# Service Bulletin

Bulletin No.: 16-NA-051

**Subject:** Active Shutters Inoperative, Malfunction Indicator Lamp (MIL) Illuminated - DTCs P05AE, P059F, P151F, P0071, P0072, P0073, P0074, P3056, U1345, U1501, U1510, U1511 Set

4787001

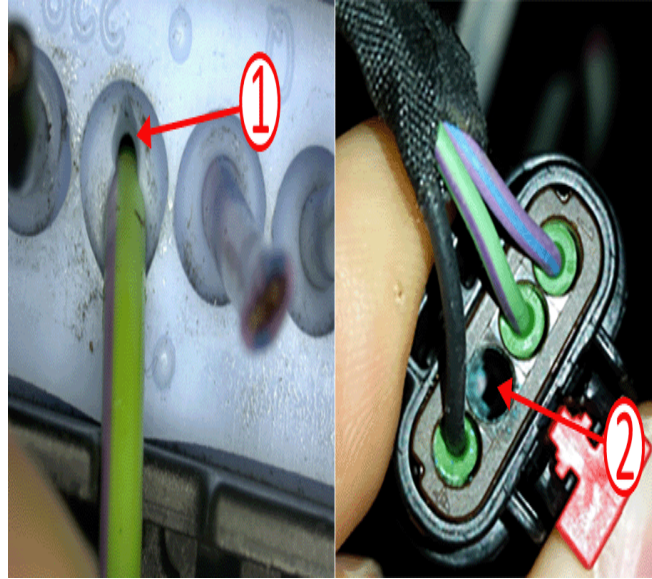
- Moisture intrusion past damaged (1) and/or missing (2) seals located in the B9, M60B and/or X119 connectors for the ambient air temperature sensor wiring harness.
- Snow and/or ice buildup in the front lower grille area of the vehicle, which could prevent the active aero shutters from opening or closing.

4527562

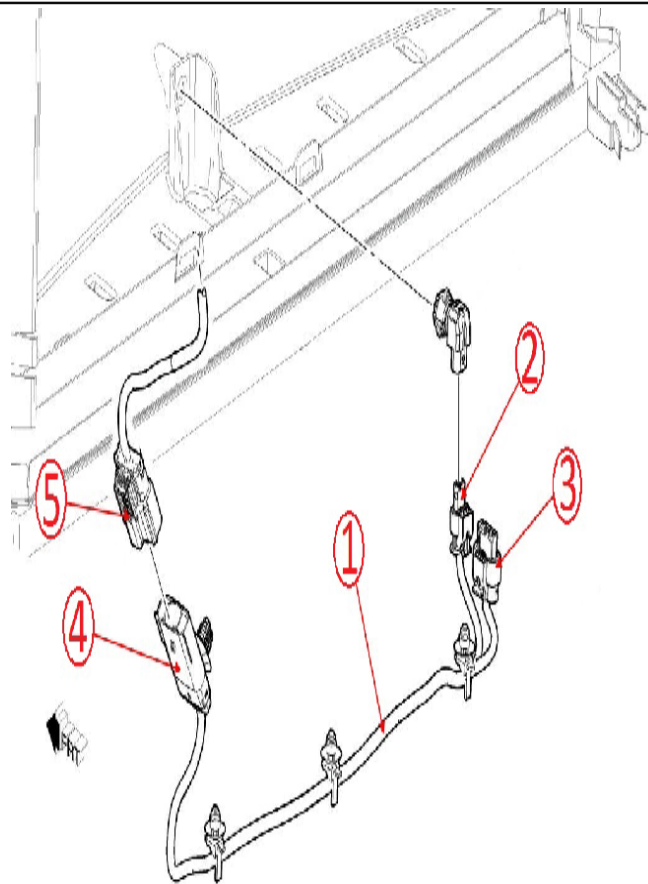
Inspect the ambient air temperature sensor wiring harness connectors B9 (2), M60B (3) and the X119 (4, 5) for any signs of corrosion.

**Notice:** The Ambient Air Temperature Sensor Wiring Harness must be replaced and dielectric grease must be applied to all of the connectors for any of the following repairs.

- If any signs of water and/or corrosion was found on the Ambient Air Temperature Sensor Wiring Harness (1), it must be replaced.
- If water and/or corrosion was found at the X119 connector (5), the main body wiring harness connector must be replaced.
- If water and/or corrosion was found at the B9 connector (2), the ambient air temperature sensor must be replaced.
- If water and/or corrosion was found at the M60B connector (3), the active shutter must be replaced.
